# CITY PLAN COMMISSION STAFF REPORT

October 18, 2022

**Project Name**  
The Depot on Old Santa Fe

**Request**  
CD-CPC-2022-00161  
Rezoning to UR/MPD  
(Residential Development Plan) &  
Preliminary Plat

**CLUBHOUSE  
 ELEVATIONS**

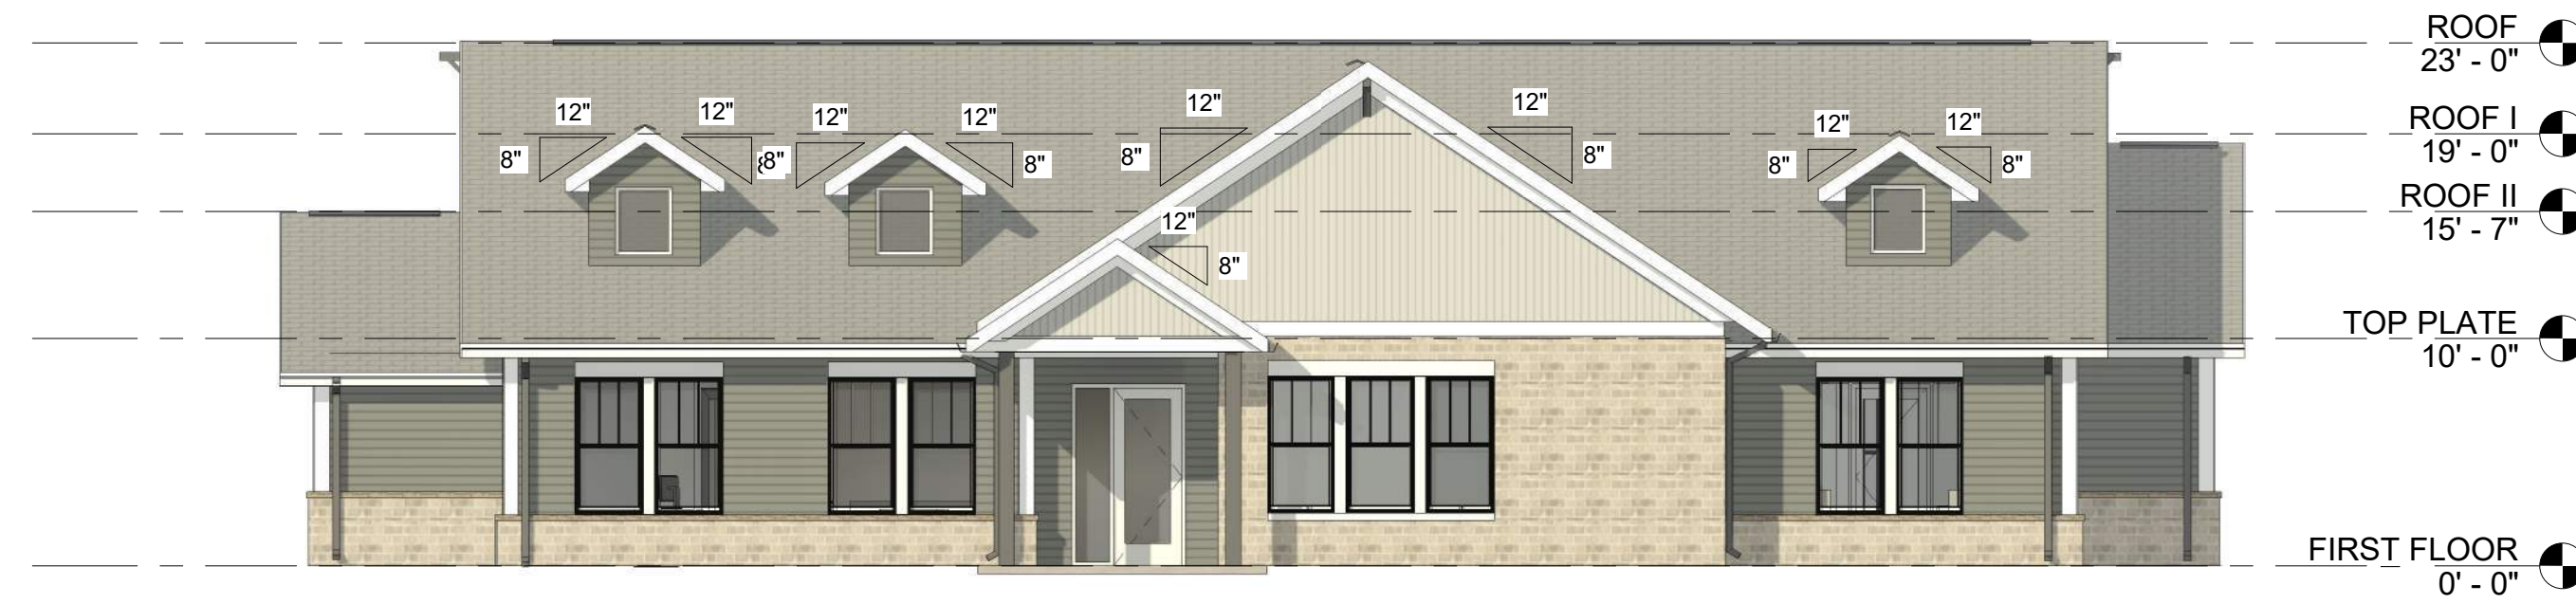
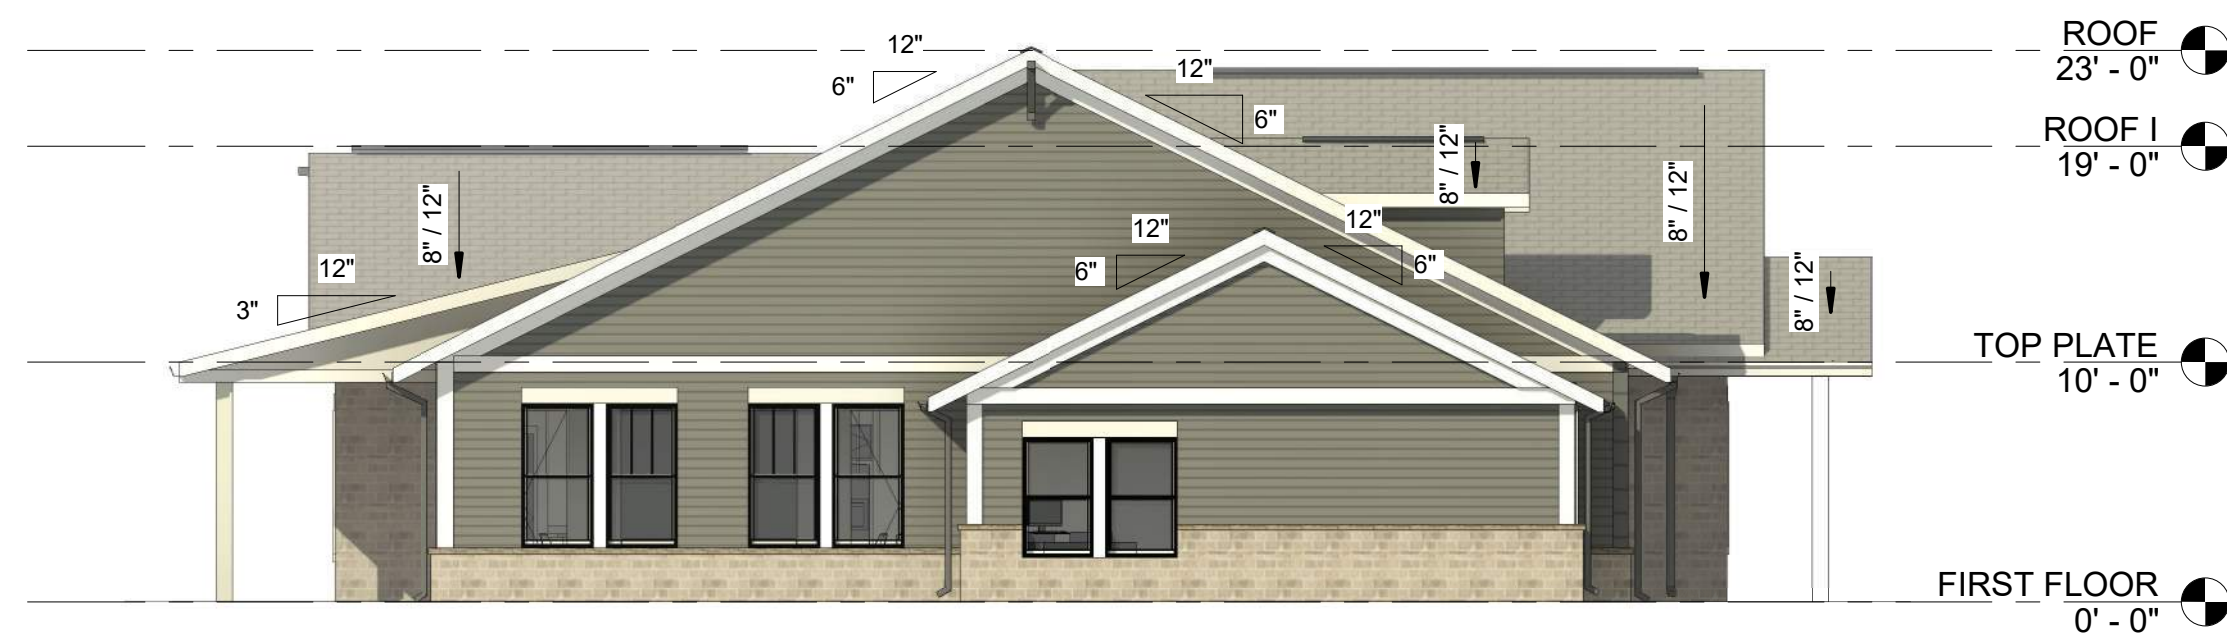
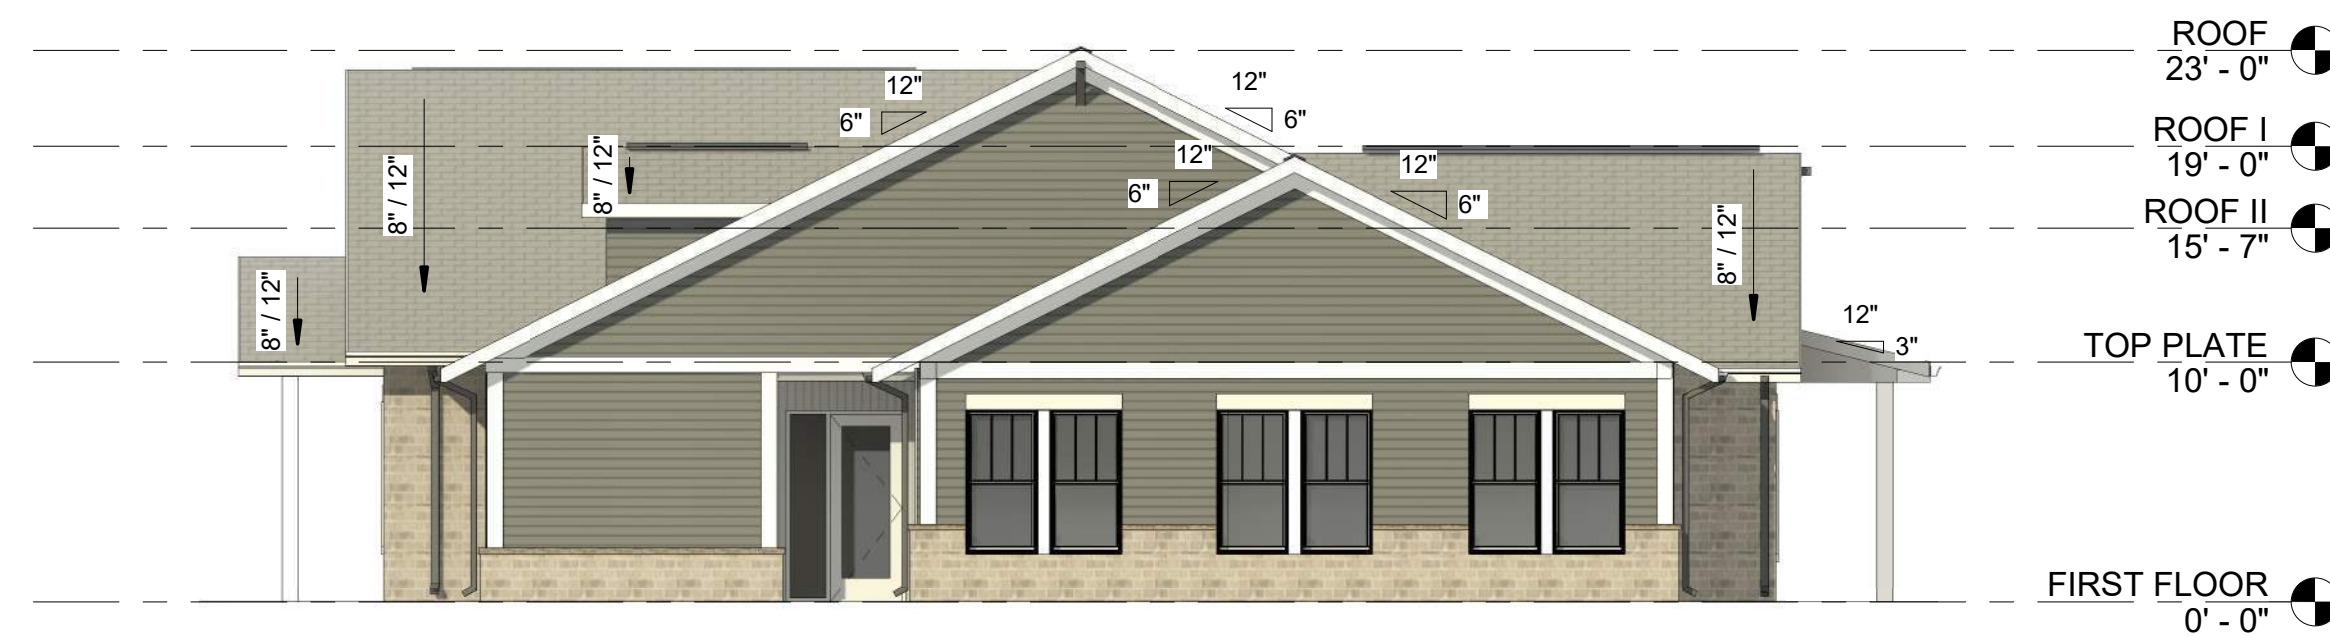
The general design and materials of the proposed seven (7) buildings complies with the Hickman Mills Area Plan, except that staff has asked the applicant to replace the proposed vinyl with a higher quality building material. Although vinyl is not outright prohibited in the Zoning and Development Code staff generally discourages this proposed material for any project which sets a poor precedent. The Hickman Mills area plan explicitly calls for materials that include brick, wood, metal, glass, concrete, stone, stucco, cast stone, terracotta, tile and masonry. The applicant has agreed to work with Development Management staff to remove the proposed vinyl and incorporate higher quality building materials.

7. The applicant shall work with Development Management staff to replace the proposed vertical 2x6 vinyl board with a higher quality building material prior to approval of the UR Final Plan.
